Runnymede Park Improvements

Community Advisory Group (CAG) Meeting 1 and Park Site Meeting

Summary Report

Image 2 Curvilinear Park Design Option

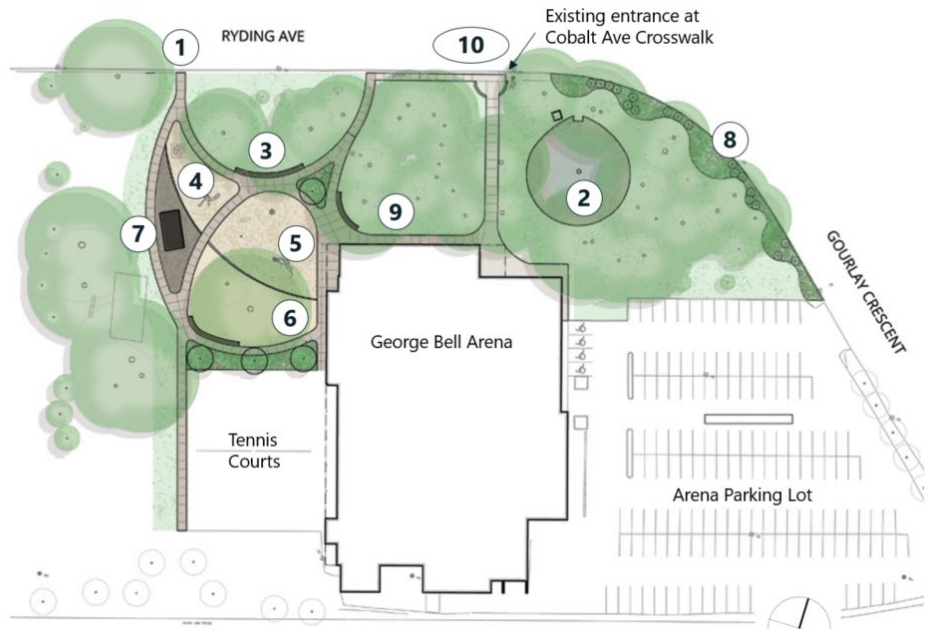
- **CAG participants who provided feedback did not identify a strong preference for either the Curvilinear or Geometric design options.** Feedback included:

- A preference for curved seating similar to Carlton Park (armour stone seating)
 - A preference of a circular path/loop for bike use, jogging, and walking

- A preference for more curvilinear shapes in the design because it's visually pleasing, more communal, and provides a better opportunity for loops in the park paths

- Improve the existing wading pool
- **CAG participants provided feedback on what they disliked about the design options.** Feedback included:
 - Concern about wooden play elements because of termites in the area

- Concern for overcrowding the park with too many new amenities
 - Lack of formal gathering space
- **CAG participants provided feedback on what they felt was missing from the design options.** Feedback included:

- More picnic tables
 - More gathering space and amenities such as a fire pit or pizza oven
 - Dog space/run
 - A big slide that is suitable for older children

- A border around the ice rink so it could be used as a community ice rink, replacing the existing community ice rink in the west portion of the park.

- A permanent outdoor rink
 - More integrative design options that merge the play areas
 - Curved seating that would allow park users to sit together face-to-face or facing away from each other

- Games tables such as a chess table

Q: The proposed paths are nice but being at the park today I don't know that they will fulfill what the community is asking for. They will not be long jogging paths, maybe long enough for some young kids to bike but not past being a few years old. A path the entire perimeter of the park would be nice, I understand how the trees would impact machinery accessibility but maybe there are other paving options?

C: I am concerned about what looks like a lot of extra formal paths in the park. I feel they will detract from the natural beauty and openness of the park. Keep the grass! From the slides it was very difficult to imagine how it would look, but my thought was that it would be very chopped up.

R: If we are going to provide a formal path, it must be an accessible one. I.e. it needs to be at minimum 2.1m width, level, firm and slip resistant. An asphalt path throughout the park will impact many trees and be a major budget item.

R: We can certainly look at reducing the amount of paths in this location. I think we should have a look at desire lines while on site next week.
